Sundry Print Report

#### **Notice of Intent**

Type of Action: Plug and Abandonment

#### Notice of Intent - Plug and Abandonment

#### Planned P & A Wellbore Schematic

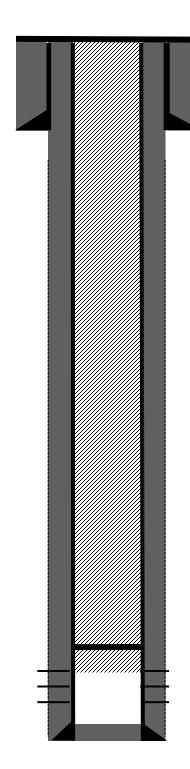
- 1. Plugging operations authorized are subject to the attached "General Requirements for Permanent Abandonment of Wells on Federal and Indian Lease."
- 2. The following modifications to your plugging program are to be made:
  - a. Complete wellbore fill up proposal. No changes to the procedure.
- 3. <u>Notification:</u> Farmington Office is to be notified at least 24 hours before the plugging operations commence at (505) 564 7750.

You are also required to place cement excesses per 4.2 and 4.4 of the attached General Requirements.
